City of Poulsbo

PLANNING COMMISSION

NOTICE OF TABLED REGULAR MEETING

Please note that the previously posted cancellation of the November 24 meeting is superseded by the Commission's action. The Commission will reconvene on November 24 to continue its consideration of Pinnacle Planned Residential Development.

SECTION G-G

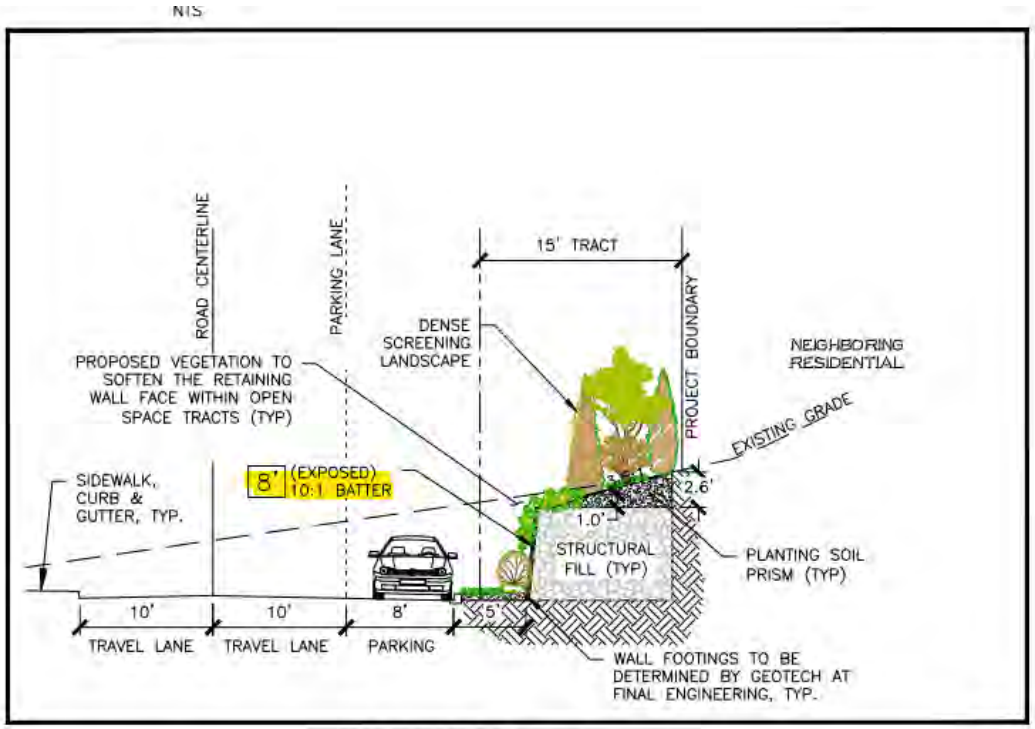
You confirmed on November 3 that Section G-G represents the fill-style retaining wall proposed directly west of Lot 46. However, the site plan shows the Tract G wall only 7 ft 3 in to 7 ft 4 in from my property line, rather than the 15 ft shown in Section G-G.

I would like the City to request the applicant to clarify this discrepancy and explain why the proposed design and dimensions are different. I expect the Tract G wall to conform to the style and dimensions shown in Section G-G, with sufficient details included in the project plans for affected property owners to understand what is actually being proposed.

In Exhibit 3.b, Section G-G describes the wall construction as "structural fill (TYP)." Based on this, I would therefore expect similar structural fill and reinforcement to be incorporated into the retaining wall design.

Given that the wall height remains approximately 8 ft, as indicated in Section G-G, while no MSE reinforcement is identified for Tract G, I am concerned about how the proposed wall will achieve adequate structural stability.

Looking at the details for section G-G, it appears that the wall height being proposed in this section is 8ft.

> Good Morning Leigh,
>
> I received an email from you regarding some questions on Pinnacle at Liberty Bay. You are correct that cross section G-G is the style of fill being proposed directly to the west of lot 46 on Crystal View.
>
> On the most recent site plan for Pinnacle at Liberty Bay, it appears the face of the proposed wall in that tract (Tract G) is around 7ft from the Crystal View Lot 46 lot line.

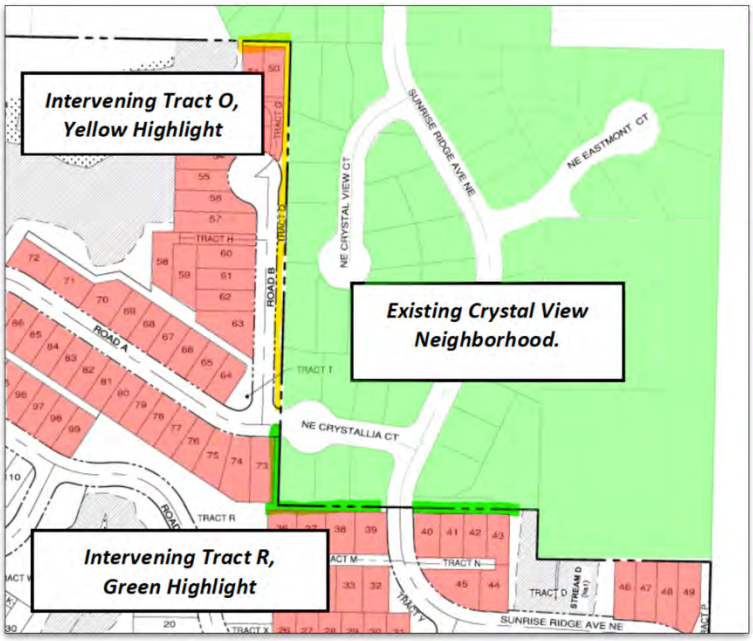
Crystal View subdivision, adjacent to lots 36 to 43 of the Pinnacle PRD. These two areas are shown below, as excerpted from Sheet PP-01 of the Pinnacle Overall Site Plan and Phasing Plan (Exhibit 2.b, dated September 16, 2026). In these areas, the Pinnacle lots (shaded in red) are significantly smaller than the adjacent Crystal View lots (shaded in green)—the Pinnacle lots are all approximately half the size of the Crystal View lots. There is simply no regularity, uniformity, or consistency between the two subdivisions in these areas. They represent dramatically different densities and lot sizes.

First, the Staff Report states that the two developments (Pinnacle and Crystal View) are "consistent" because "[t]he proposal consists entirely of detached single-family dwellings, maintaining the predominant residential housing form found in the adjoining neighborhoods." Staff Report at 25. But that is entirely irrelevant. The consistency requirement at PMC 18.260.070.A only applies when a Planned *Residential* Development ("PRD") is proposed adjacent to an "existing *single-family residential zone* which has been developed utilizing traditional city subdivision development standards and lot sizes." In other words, the whole point of the consistency requirement is to ensure that two residential developments are consistent with each other. Thus, the fact that they are both "residential" in character is a given. It is not a factor that supports, or contradicts, consistency.

Figure 1: Proposed Layout for Sunrise Ridge Ave NE

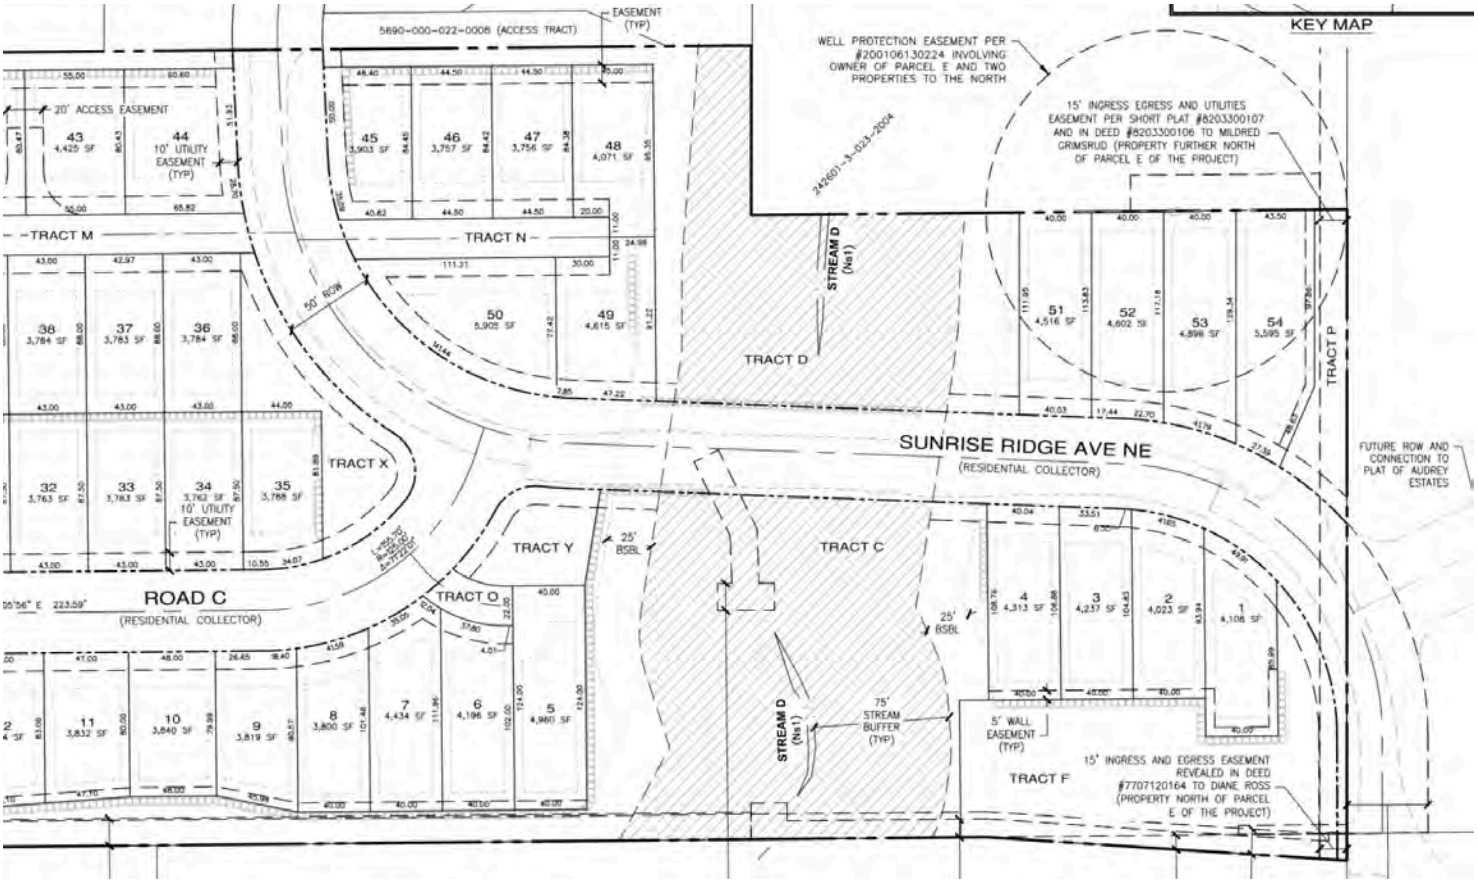
The proposed layout for Sunrise Ridge Ave NE follows the existing maintenance access road in the same location (figure 1). The new layout would increase the width of the roadway to the extent possible within the right of way (ROW) including a single vehicle lane in each direction and sidewalks on either side of the street. There are roadways connected to the proposed layout of Sunrise Ridge Ave NE to provide access to homes within the development. Additionally, residential plots are proposed having direct access to Sunrise Ridge Ave NE.

According to the City of Poulsbo Street Standards - Section 2, all intersections shall be designed with adequate sight distance in accordance with AASHTO standards. The analysis available for this development did not include a stopping sight distance study for the drivers approaching Sunrise Ridge Ave NE. The analysis of sight distance for each approach to the proposed layout of the roadway is crucial in defining risks associated with each approach and any appropriate mitigation of those risks.
